| Illinois Tollway Standard Drawing Revisions |

| Section E | Maintenance of Traffic |                                                                                                                                                                                                                                                                     |                       |
|           | Standard               | Modification Summary                                                                                                                                                                                                                                                | Effective: 03-01-2025 |

| VERSION:<br>2025-03 | STANDARD:<br>E2-12 | SHEET:<br>1 OF 3 |

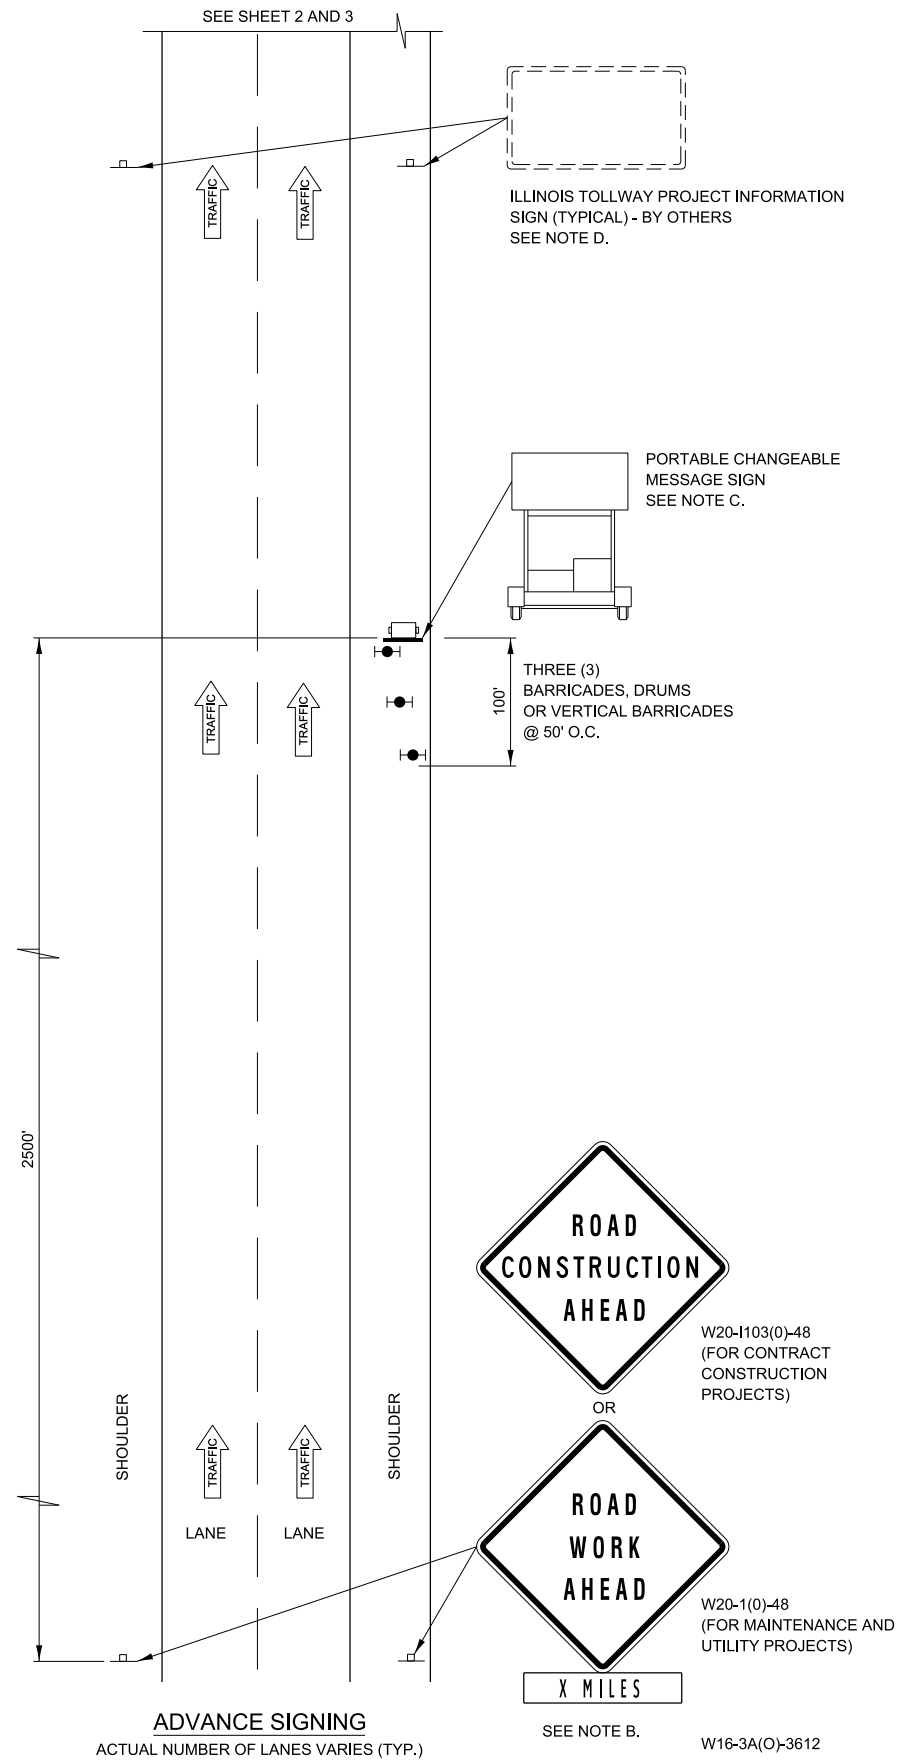
| Section E | Maintenance of Traffic |                                                                                                                                                                                                                                                                     |                       |
|-----------|------------------------|---------------------------------------------------------------------------------------------------------------------------------------------------------------------------------------------------------------------------------------------------------------------|-----------------------|
|           | Sheet 1                | Deleted "Worker" from Legend                                                                                                                                                                                                                                        |                       |

| REVISIONS  |                                                                   |
|------------|-------------------------------------------------------------------|
| 03-01-2025 | REVISED NOTE 18 TO INCREASE BUFFER TO ACTIVE LANES, DELETE WORKER |
|            | LEGEND AND WORK AREA, REVISED                                     |
|            | DIMENSIONS FOR FLAGGER SIGN TO                                    |
|            | FLAGGER, AND TMA TO FLAGGER.                                      |

**LANE CLOSURE DETAILS**

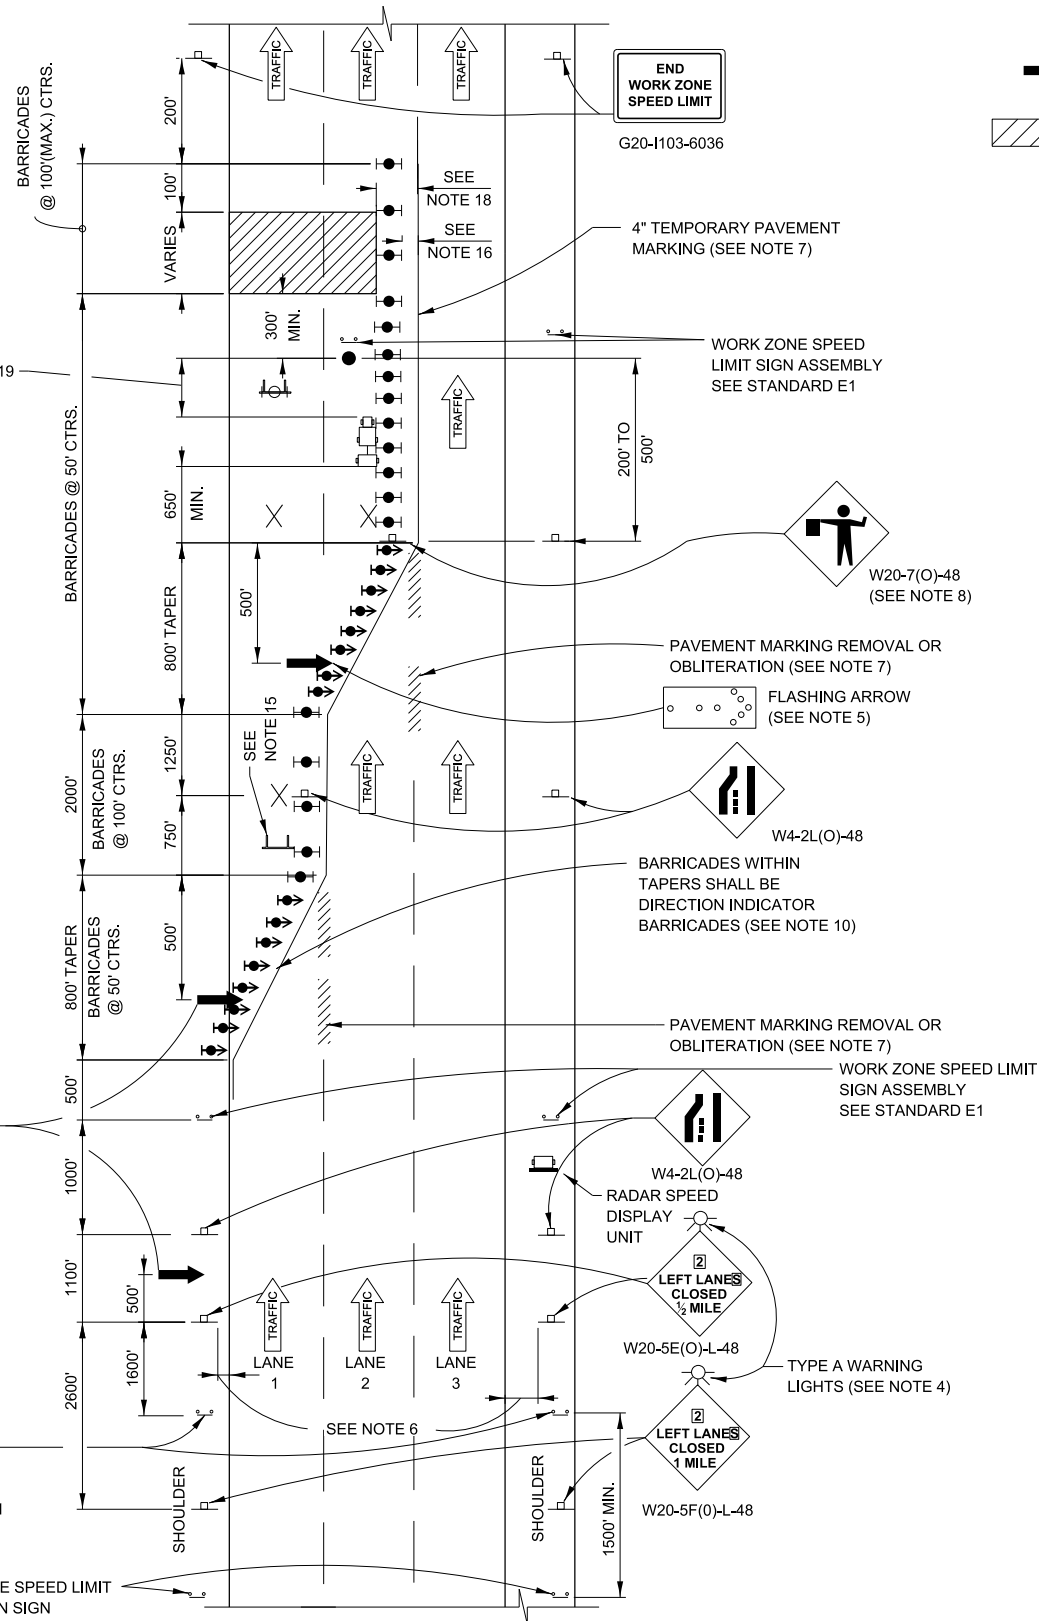
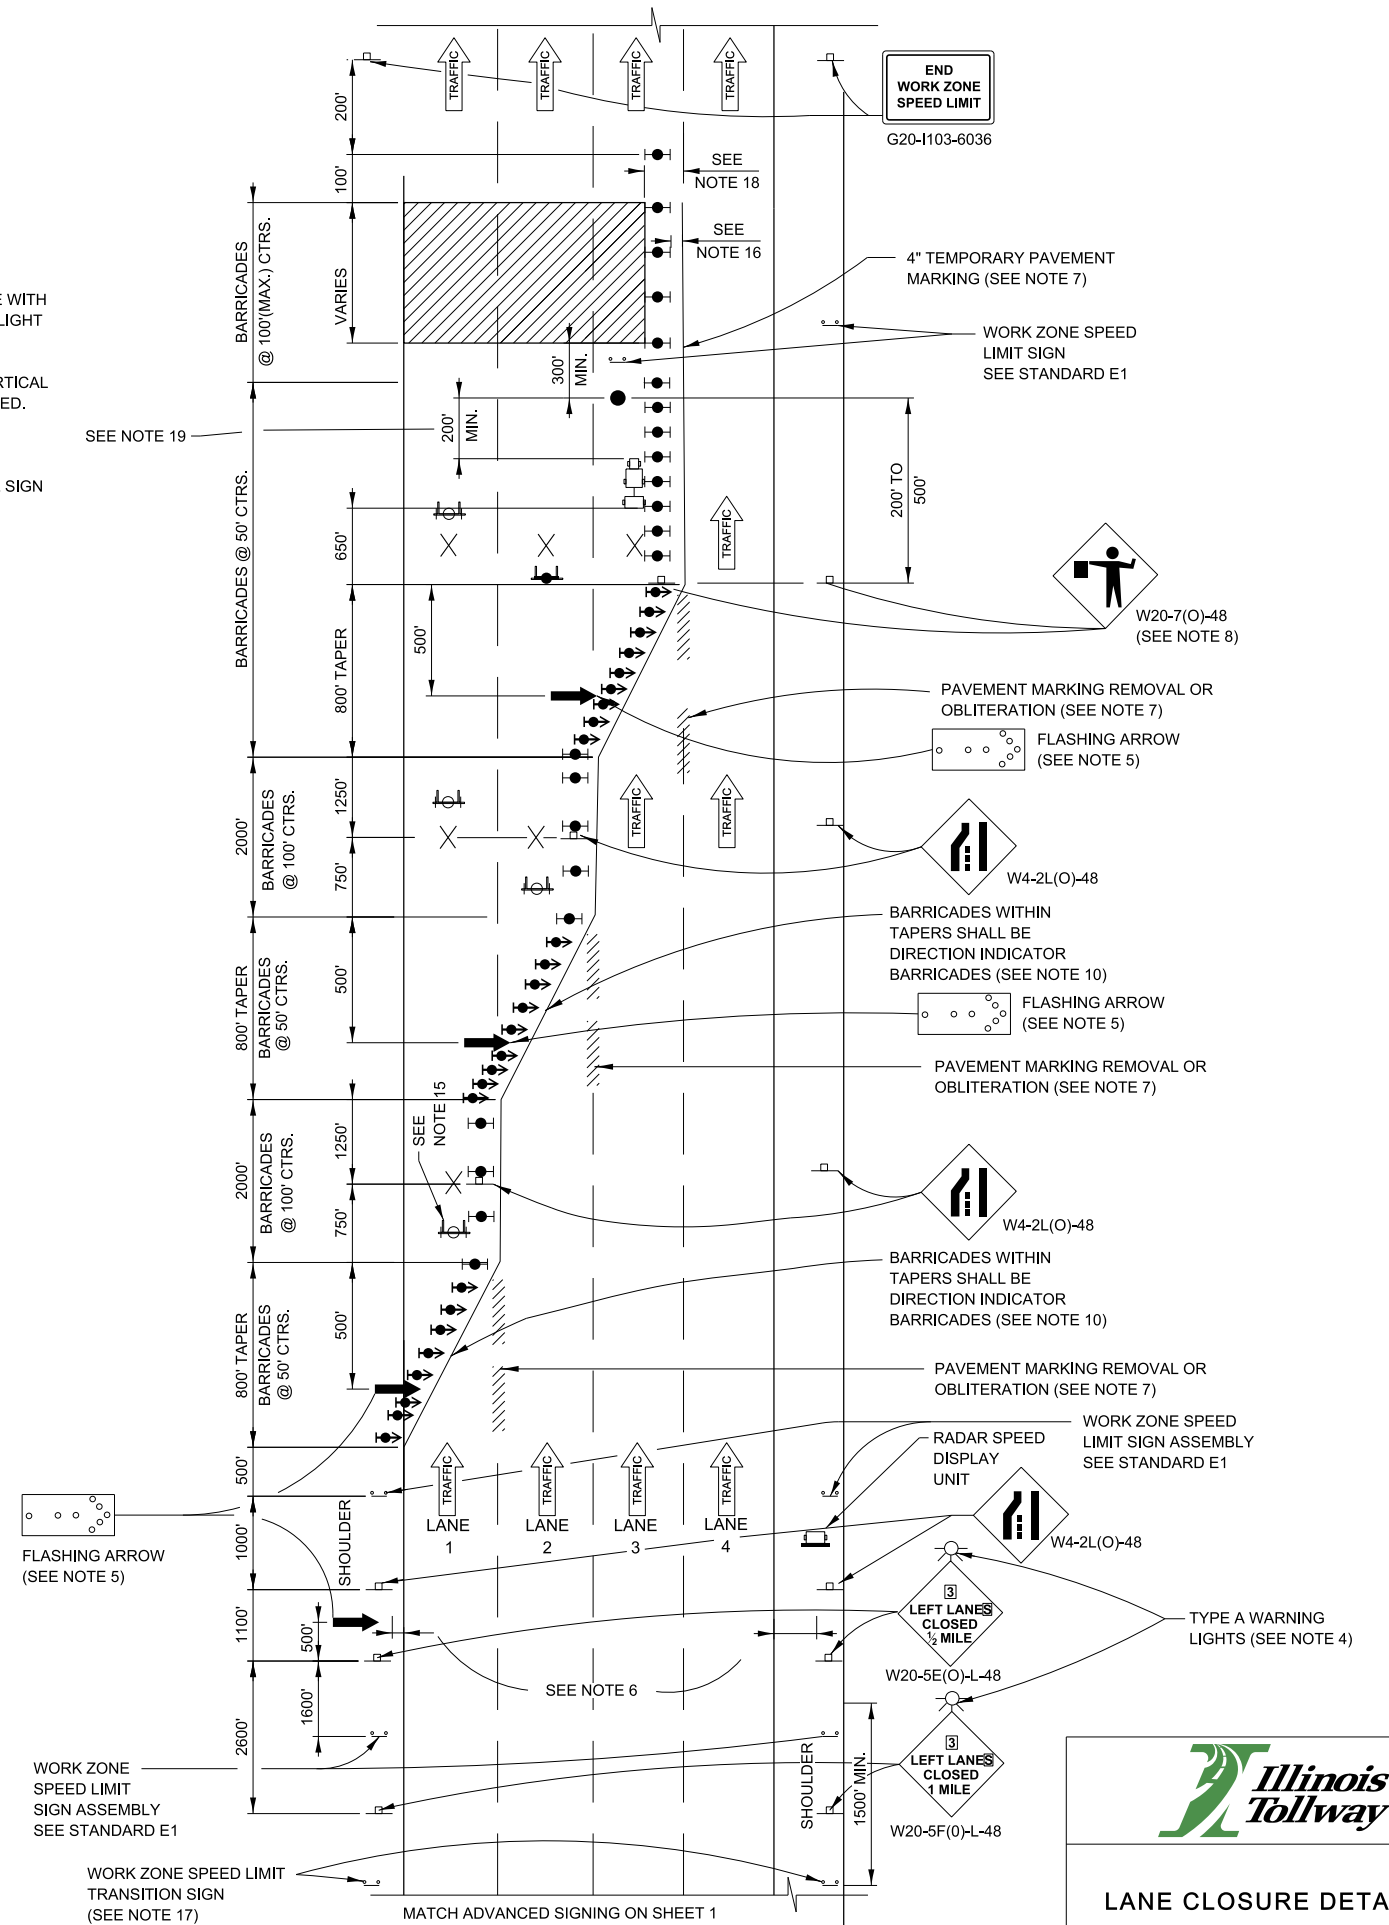
| Section E | Maintenance of Traffic |                                                                                                                                                                                                                                                                     |                       |
|-----------|------------------------|---------------------------------------------------------------------------------------------------------------------------------------------------------------------------------------------------------------------------------------------------------------------|-----------------------|
|           | Sheet 2 & 3            | Deleted "Worker" from Legend and work area. Removed "Flagger" from work area hatching. Revised distance from Flagger sign to flagger and flagger to work area. Revised note 18 to increase buffer to active lane and revised description for flagger in the legend. |                       |

SHOULDER CLOSURE  
DETAILS

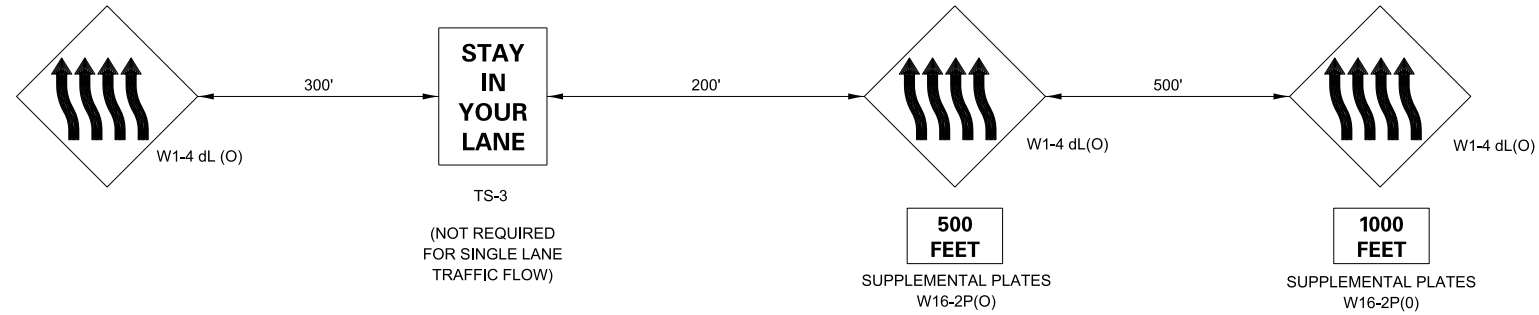
| Section E | Maintenance of Traffic |                                                                                                                                                                                                                                                                     |                       |
|-----------|------------------------|---------------------------------------------------------------------------------------------------------------------------------------------------------------------------------------------------------------------------------------------------------------------|-----------------------|
|           |                        | Revised Notes 1 and 2 to increase buffer to active lane.                                                                                                                                                                                                            |                       |

| REVISIONS  |                                                                                  |
|------------|----------------------------------------------------------------------------------|
| 03-01-2025 | REVISED NOTE 1 AND 2 TO INCREASE<br>BUFFER TO ACTIVE LANES                       |
